Docket Item # 4  
BAR CASE #2010-0237

BAR Meeting  
September 15, 2010

**ISSUE:** Window Replacement

**LOCATION:** 1208 Prince Street

# WOOD ULTIMATE DOUBLE HUNG

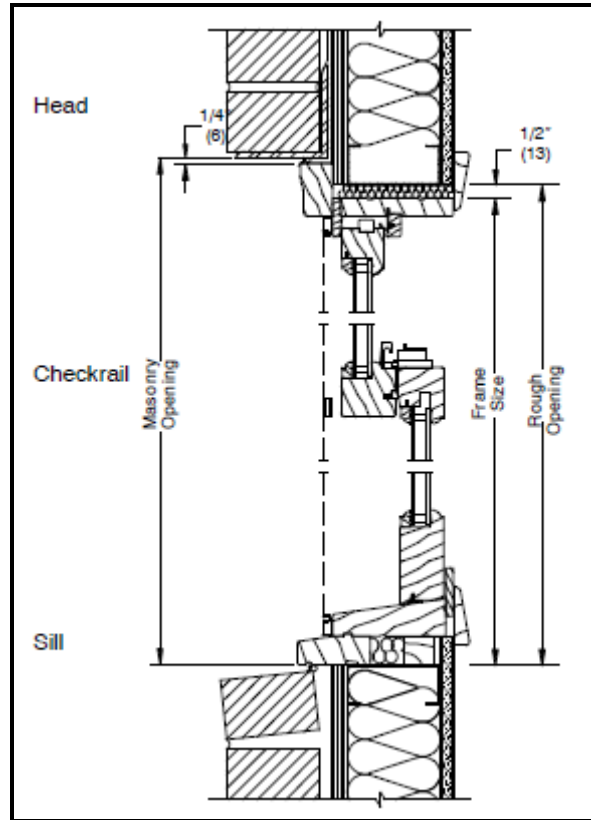
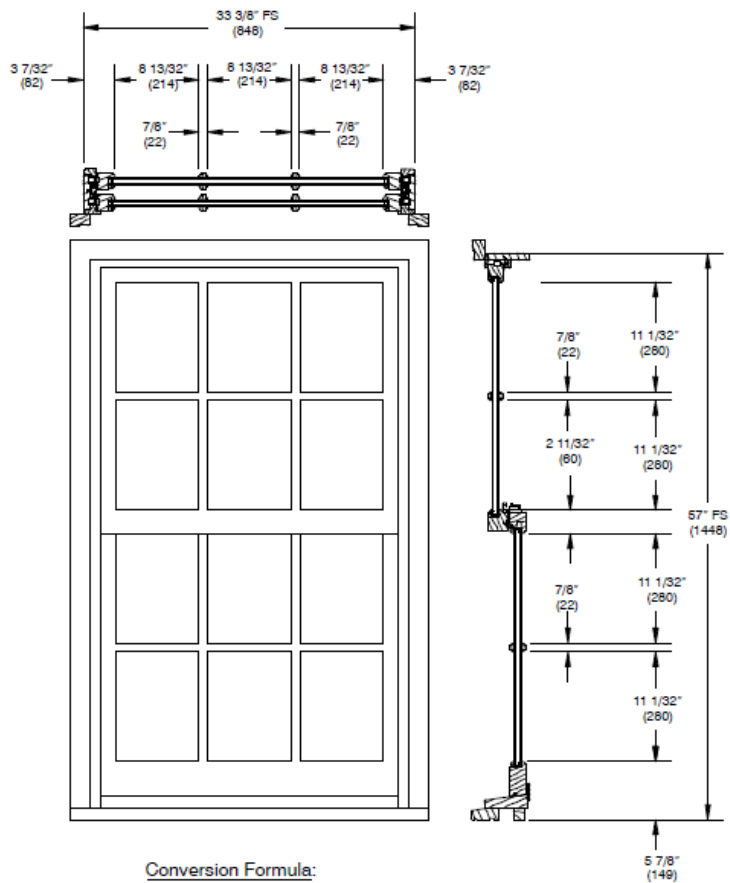
Although the house dates to the beginning of the 19<sup>th</sup> century, the existing windows on 1208 Prince Street are clearly not original and probably date from the early-to-mid 20<sup>th</sup> century based on the lack of 19<sup>th</sup> century cylinder glass and use of aluminum tracks. It is a central tenet of Historic Preservation that historic materials be maintained and repaired rather than replaced. However in this case the existing windows are not original and Staff does not find their removal problematic. Nevertheless, due to the age of the building, location within the district, and its visual prominence on the street, Staff finds the applicant's proposal of simulated divided light, double glazed windows with 7/8" wide muntins inappropriate.

The applicant is proposing a 7/8" wide muntin bar. As the current windows are not original to the house, Staff must utilize historic documentation to make a recommendation on a historically appropriate muntin width. As a general rule, technological improvements in the early 18<sup>th</sup> century allowed the use of larger glass panes, which altered the proportions of glass panes and muntins. Generally, early Georgian style windows with smaller panes of glass utilized wide muntins whereas larger panes of glass in the later Federal and Greek Revival periods were fitted to narrow muntins. (McAlester, Virginia, McAlester, A. Lee. (1984). *A Field Guide to American Houses*. Knopf, New York) As such, due to the age of this house, Staff believes that a 5/8" muntin with a putty profile on the exterior is the appropriate size for the scale of the existing window openings. The contractor has indicated that the proposed window manufacturer offers muntins in this narrower width on special order.

Besides the width of the muntin, the muntin depth and glass thickness of single pane window profiles are an important visual characteristic of older buildings. While Staff supports the use of modern, simulated divided light windows on all portions of Recent buildings in the District, the shadows from the spacer bars on these windows do not recreate the effect of single pane windows when viewed up close and at an angle while walking down the sidewalk and, based on the instructions of the *Design Guidelines* and past practice of the Board, believes the Early buildings should be held to a higher standard of compatible replacement materials.

1. That the new windows on the street façade be single-glazed, true divided light wood windows with a separate storm panel;
2. That the applicant may use true divided light or simulated divided light windows on the side elevation;

4. That the replacement windows be solid wood, including the muntin bars;
5. That the glazing on the glass be tint free (certain types of low e glass meet this recommendation);

6. That the width of the muntins in the replacement windows be 5/8" wide with a putty glaze profile on the exterior;
7. That the frame for the screens match the color of the window frame and that the screens be a medium dark color and not white;

8. That the replacement window sash corners be constructed with mortise and tenon style, butt joinery rather than mitered, picture frame joinery;
9. That the replacement windows be constructed with a wood jamb liner rather than a vinyl jamb liner, or that the visual portion of the vinyl jamb be very minimal;

Therefore, Staff recommends only single-glazed true-divided light wood windows for the street façade of this early/mid 19<sup>th</sup> century dwelling but has no objection to the use of simulated divided light windows for the replacement of non historic sash on the less visible side and rear elevations. Staff notes that several manufacturers offer a single glazed window with a removable energy panel that attaches directly to the window sash and functions as a storm window. These energy panels may be coated with low-e film and provide a u-value almost equal to simulated divided light sash.
